PORTOLA ELEMENTARY SCHOOL PLAYGROUND REPLACEMENT

ADDENDUM #01

BID ADDENDUM NO. 1 ISSUED 11/20/2025

PORTOLA ELEMENTARY SCHOOL PLAYGROUND REPLACEMENT
PORTOLA ELEMENTARY
PROJECT NO. **E1-25**

A-1.05

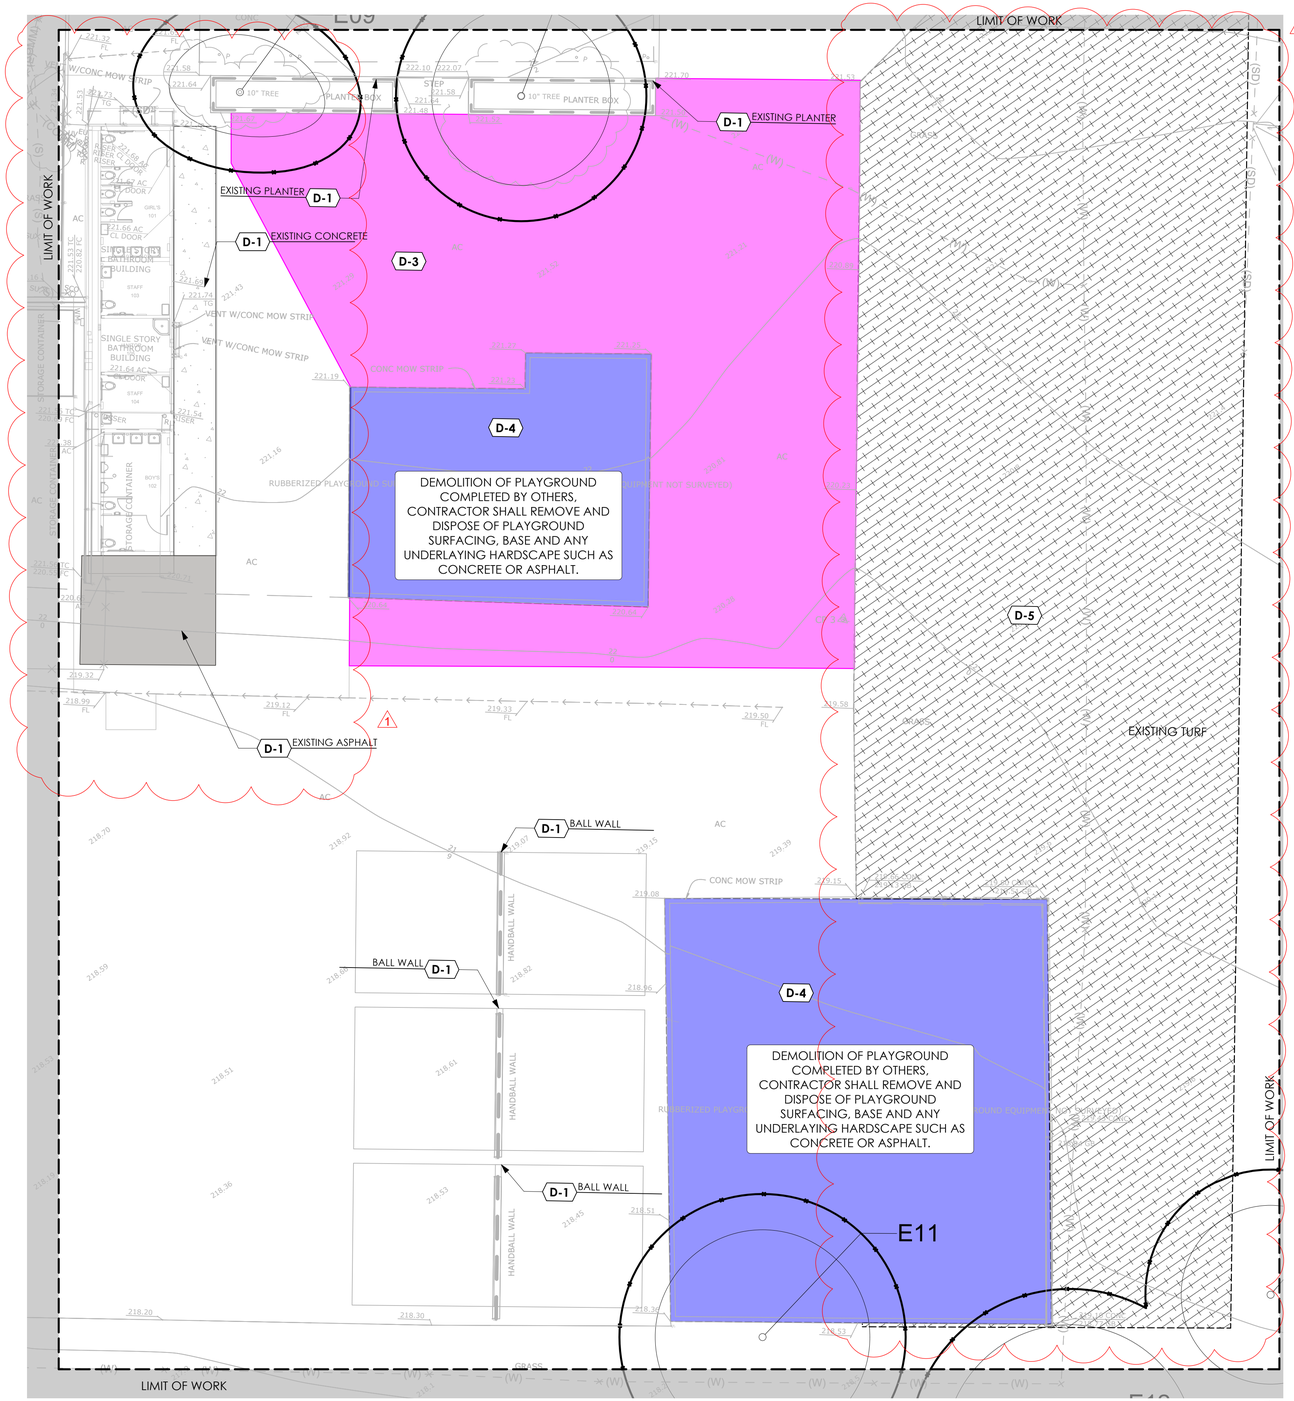
Item 1 **A-1.05 SITE ACCESS PLAN & DETAILS**
Area of work referenced on landscape drawings updated to include basketball courts and surrounding hardscape.

Date	10/20/2025
Drawn by	EM
Checked by	BM, MZ
Sheet Number	LD-1.02

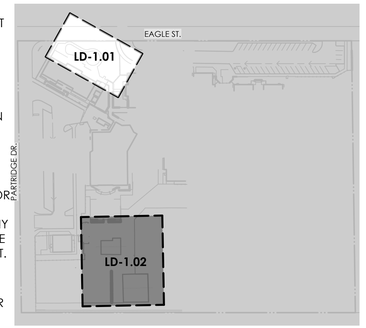
Item 2 **LD-1.02 DEMOLITION PLAN**
Updated AC removal scope and “clear & grub” scope per demolition schedule items D-3 and D-5 respectively.

LC-0.01

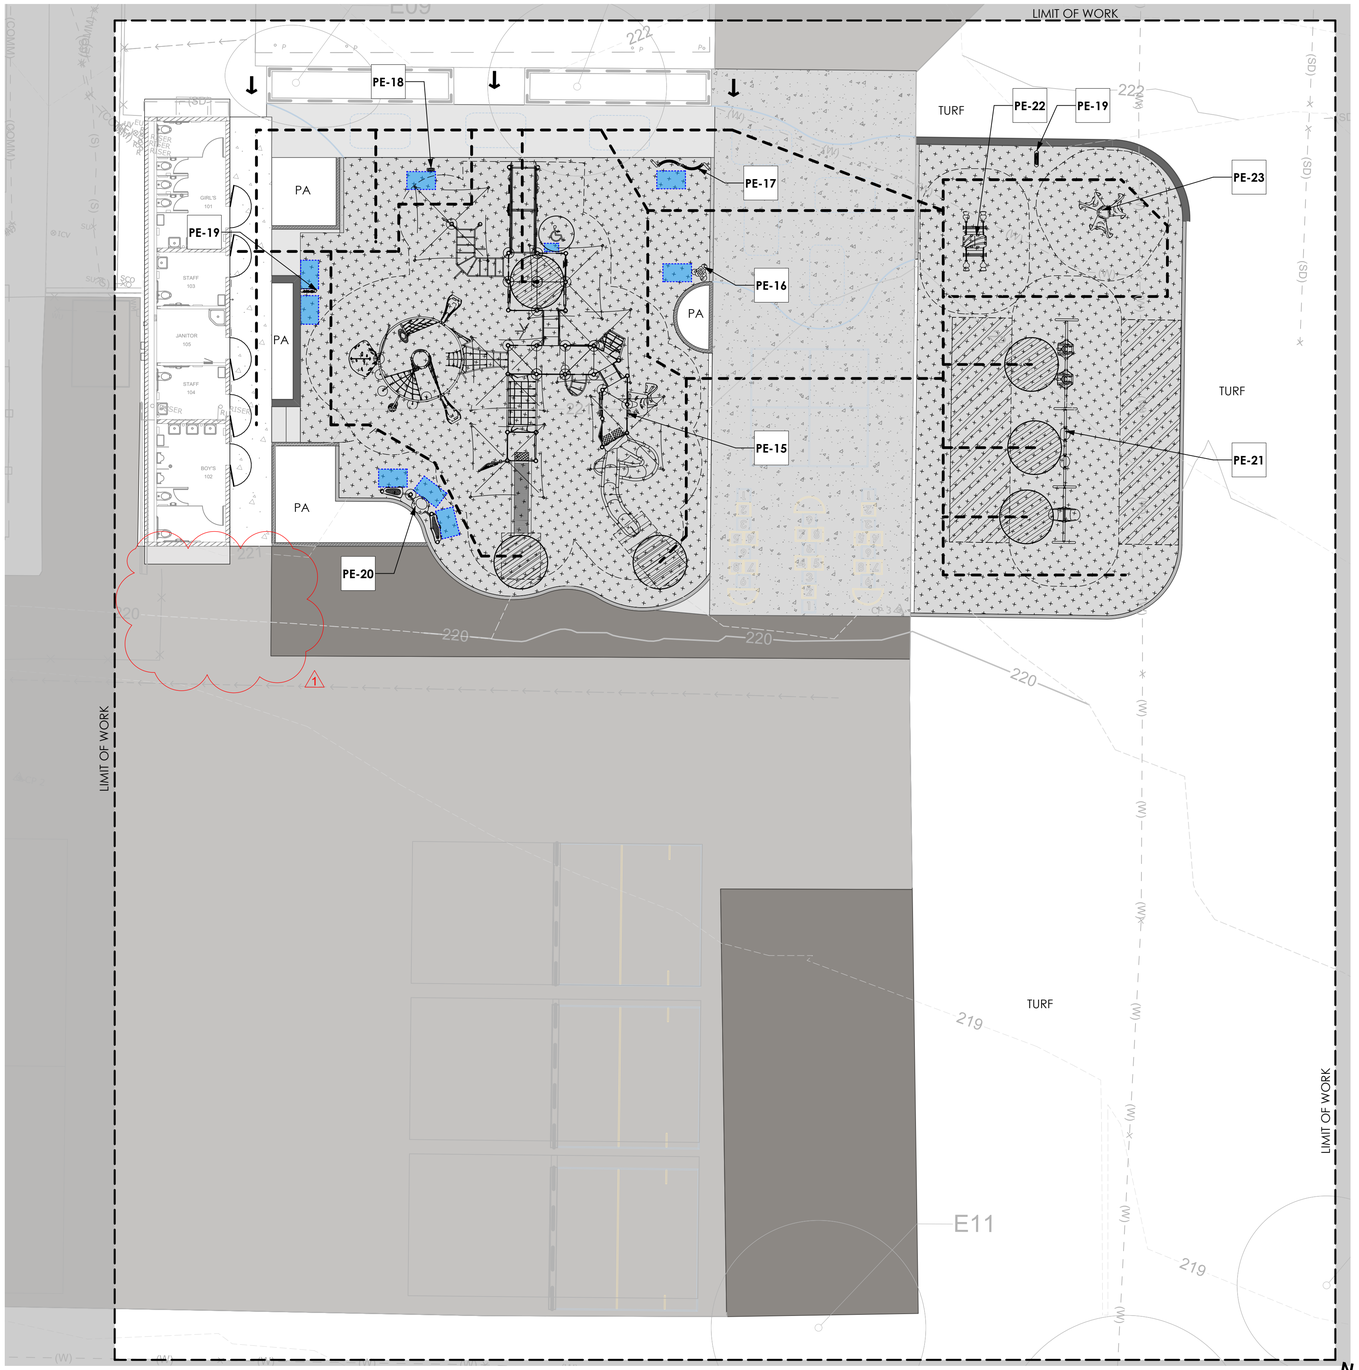
Item 3 **LC-0.01 CONSTRUCTION NOTES & SCHEDULES**
Updated paving schedule items P-3, P-4, and P-11.

LC-0.04

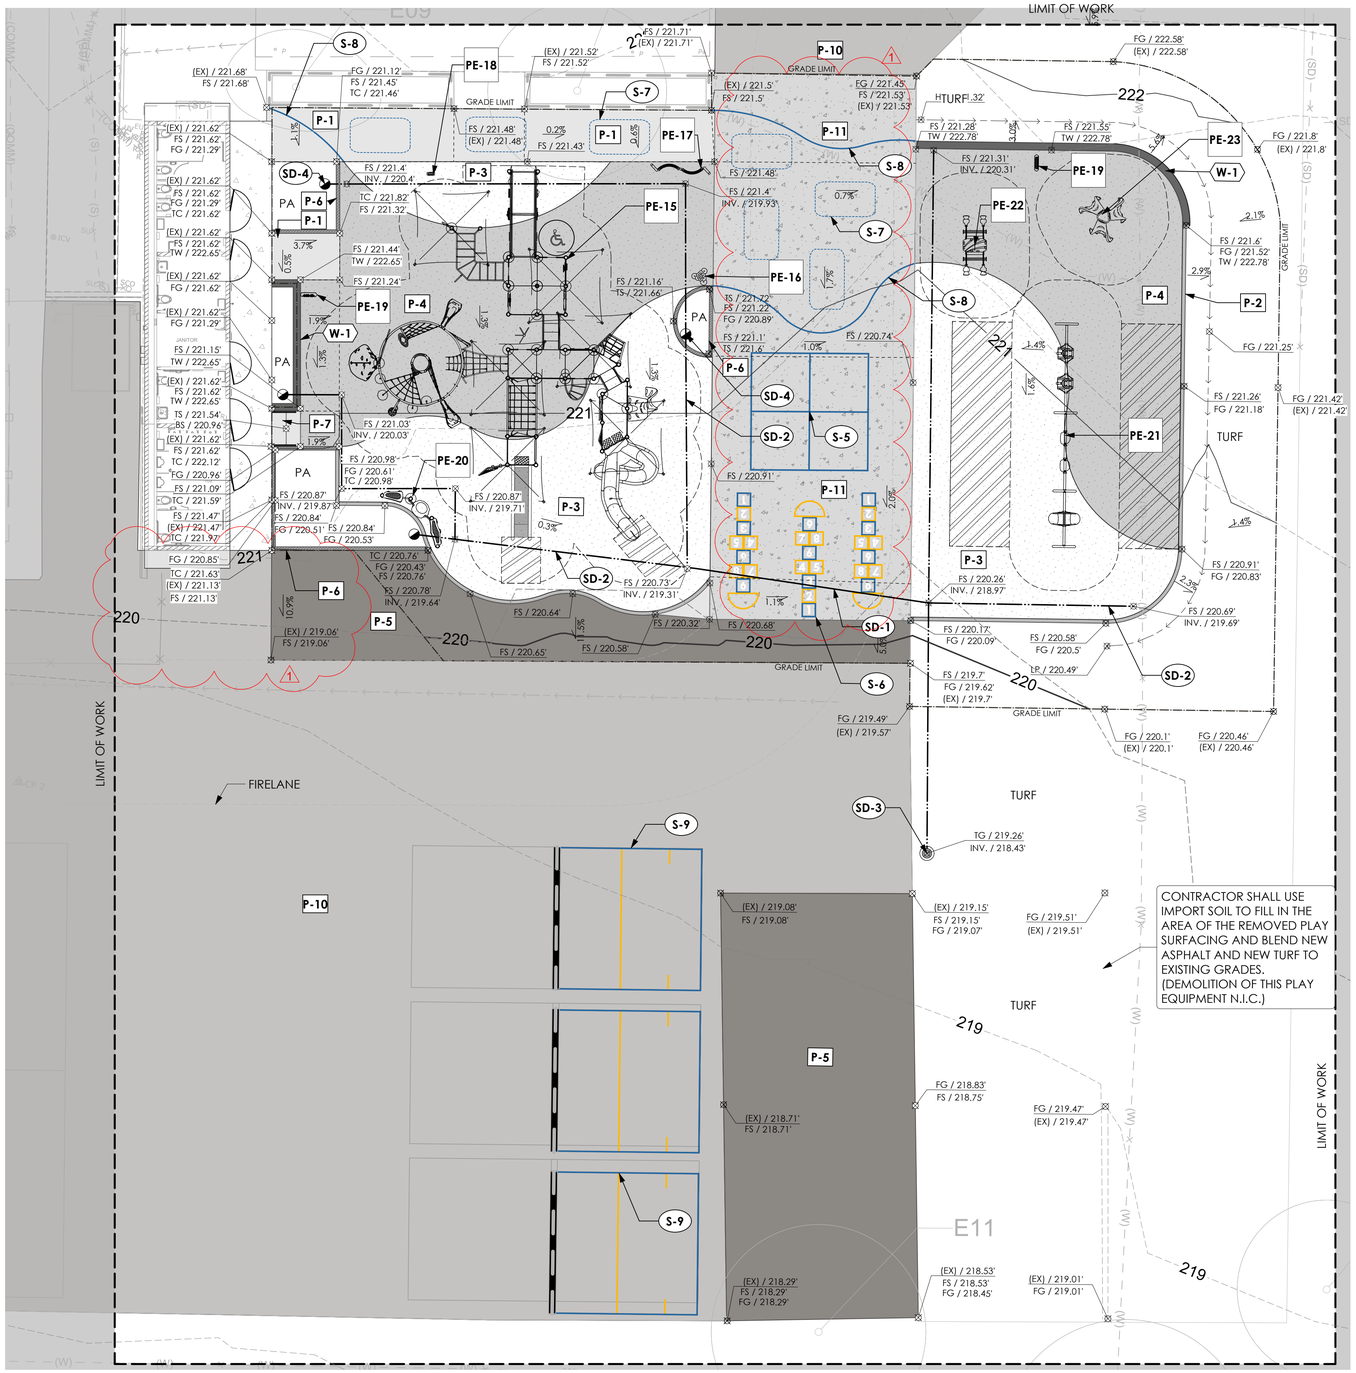
Item 4 **LC-0.04 PLAYGROUND ACCESSIBILITY PLAN**
Updated AC paving scope south of existing modular restroom.

LC-1.02

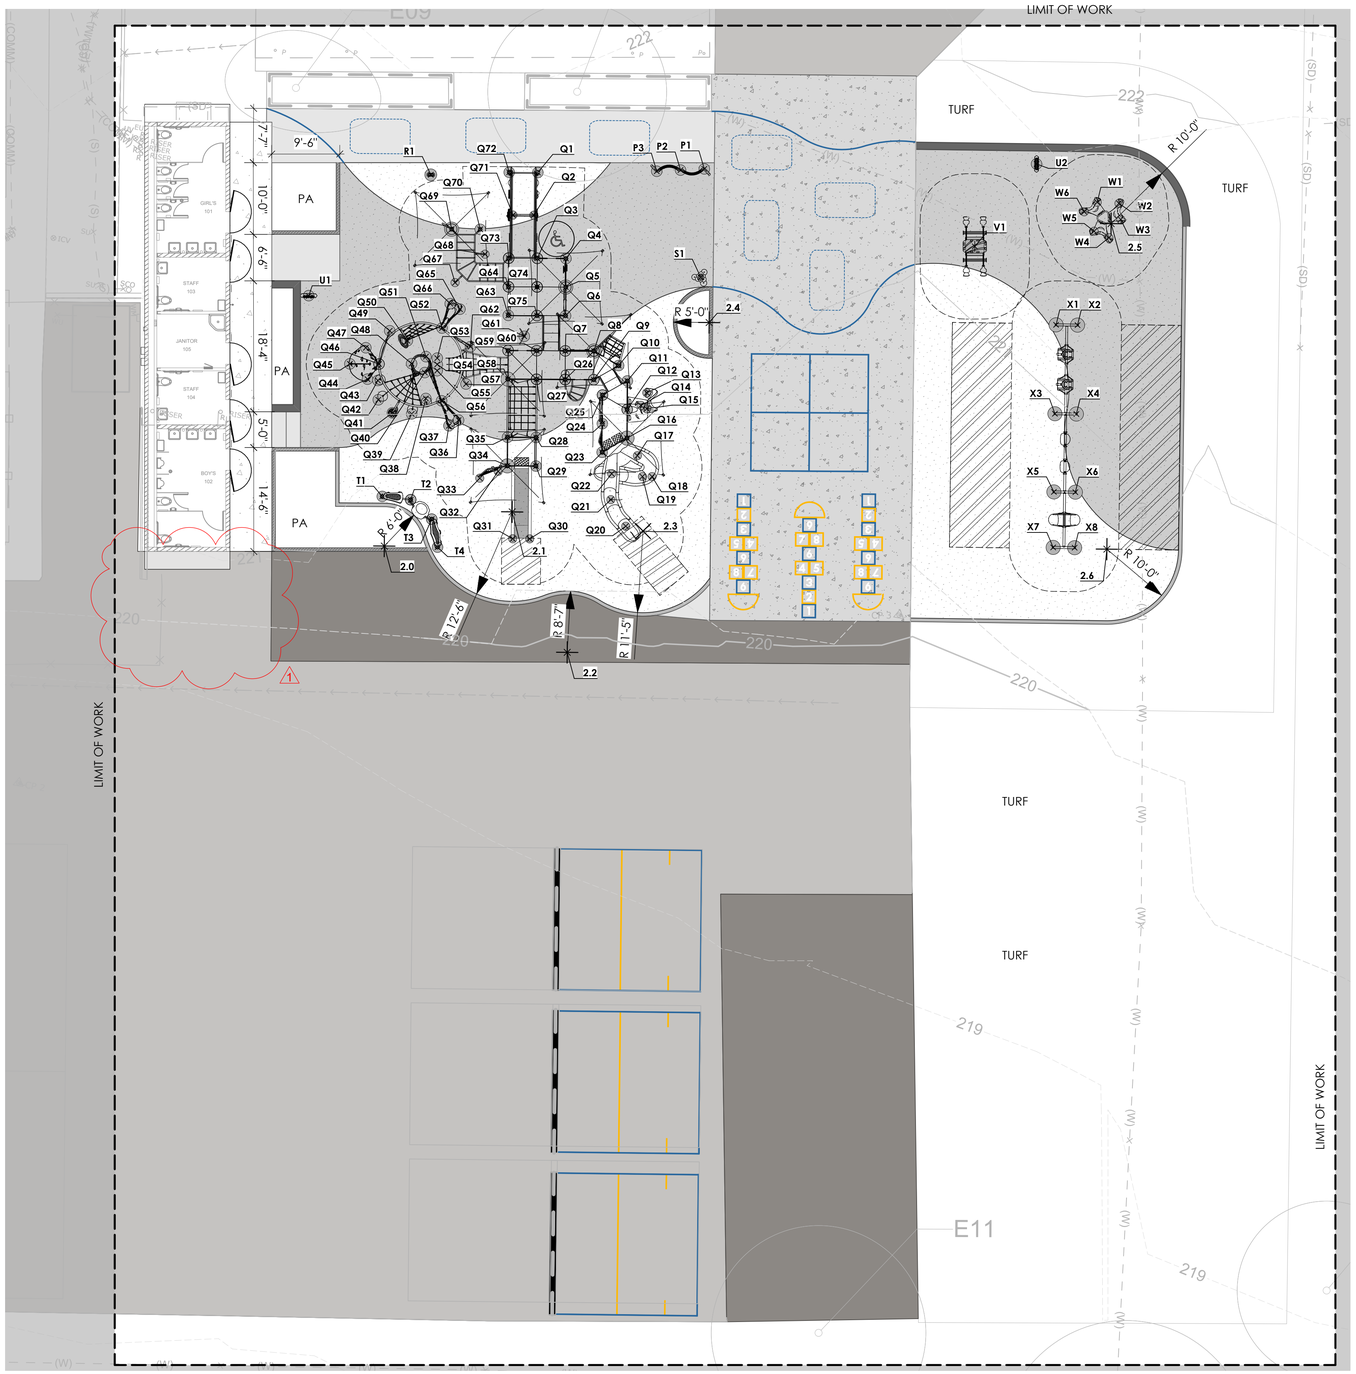
Item 5 **LC-1.02 CONSTRUCTION & GRADING PLANS**
Updated AC paving scope south of existing modular restroom. Added item P-11 changing the hardscape in between the play structures from pedestrian concrete paving to vehicular concrete paving.

LC-2.02

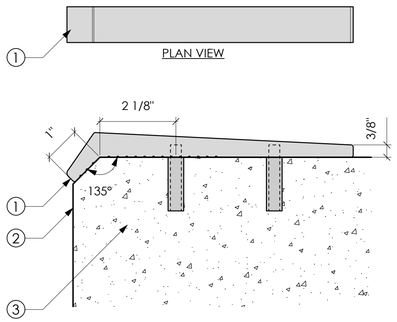
Item 6 **LC-2.02 HORIZONTAL CONTROL PLAN**
Updated AC paving scope south of existing modular restroom.

J CONCRETE PAVING- VEHICULAR

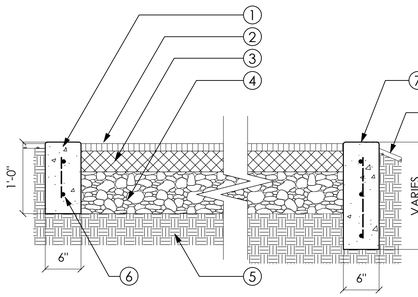
Item 7 **LC-3.01 CONSTRUCTION DETAILS**
Added detail “J” Concrete Paving – Vehicular.

G POURED IN PLACE RUBBERIZED PLAY SURFACING AT CONCRETE PAVING

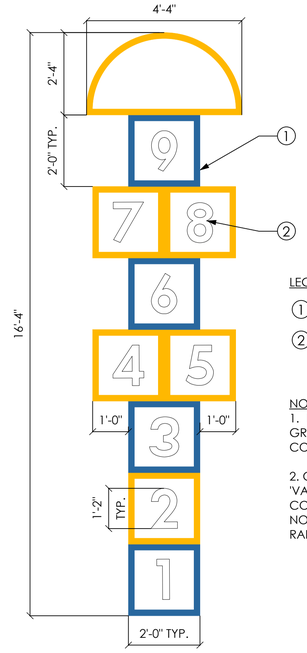
Item 8 **LC-3.02 CONSTRUCTION DETAILS**
Added detail “G” Poured in Place Rubberized Play Surfacing At Concrete.

10	Please provide a transition detail between P1 Concrete Paving and Rubber Surfacing at locations where there is no concrete header. Please advise?	See detail included in the bid addenda. See detail G/LC-3.02.	PCLD
11	Please confirm the synthetic turf scope of work is by others. GC is only providing base underneath. Please advise?	Confirmed. Synthetic turf scope will be completed by others.	VUSD
